Project	IEEE 802.16 Broadband Wireless Access Working Group < http://ieee802.org/16 >	
Title	Corrections and clarifications to OFDMA LDPC Coding	
Date Submitted	2005-06-08	
Source(s)	Robert Xu, Liujun Hu ZTE Inc. 5/F, Bldg.702, Pengji Industrial Park, Liantang, Shenzhen, 518004	Voice: +86 755 26773000 6574 Fax: +86 755 26773000 6616 mailto: xu.jun2@zte.com.cn hu.liujun@zte.com.cn
Re:	Response to Sponsor Ballot on IEEE802.16e/D8 document	
Abstract	In this contribution, we suggest that some text description should be modified to make the matrix be uniform with the text description.	
Purpose	To incorporate the text changes proposed in this contribution into the 802.16e/D8 draft.	
Notice	This document has been prepared to assist IEEE 802.16. It is offered as a basis for discussion and is not binding on the contributing individual(s) or organization(s). The material in this document is subject to change in form and content after further study. The contributor(s) reserve(s) the right to add, amend or withdraw material contained herein.

Corrections and clarifications to OFDMA LDPC Coding

Robert Xu, LiuJun Hu
ZTE Inc.

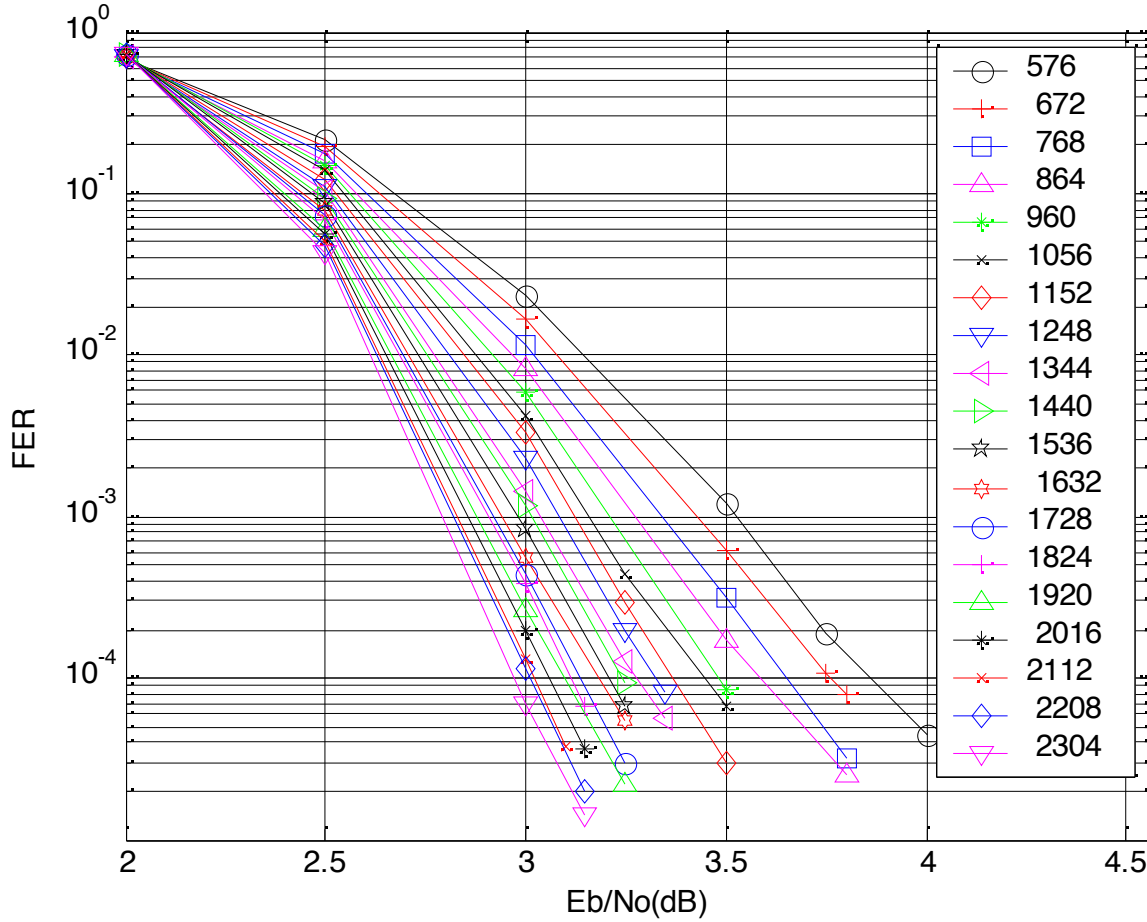
Simulation results for the rate 3/4 code B families are shown in Figure 1. For the rate, code sizes considered are all 576-2304. The simulation conditions are: AWGN channel, BPSK modulation, max iterations times 50, using generic floating-point belief propagation. From the simulation results we can find that our codes overcome the “error floor” phenomenon, and the BER curve of them will descend more steeply. When SNR is high, our high girth method obviously obtained an improved performance. The expansion factor z ranges from 24 to 96, as shown in Figures 1. The block size and the expansion factor are related by $n = 24 * z$.
